TECHNICAL BULLETIN TECH-11-2023 REV-B

PSA 1.2L – 870248-5002S TURBOCHARGER REPLACEMENT

DECEMBER 2023

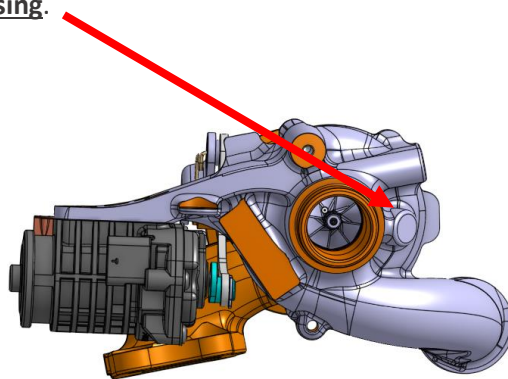
Please note that this Tech bulletin is to inform you of a mistake that was recently made in our online catalogue in specifying the wrong turbocharger PN 901680-5002S as replacement of turbochargers PN 887157-5001S & PN 870248-5002S, which is not a direct service replacement for the following reason explain below.

- TC 901680-5002S is a standalone turbocharger as it doesn't use the e-RCV valve on the compressor housing.

- The correct direct service replacement is as follow: TC PN 870248-5002S replaced by TC PN 887157-5001S as they are using the same e-RCV.
Also in order to do the conversion from TC 870428-5002S to 887157-5001S you will need to purchase from a PSA agent the oil pipe feed PN 98 328 034 80 & the oil drain pipe PN 98 329 260 80.
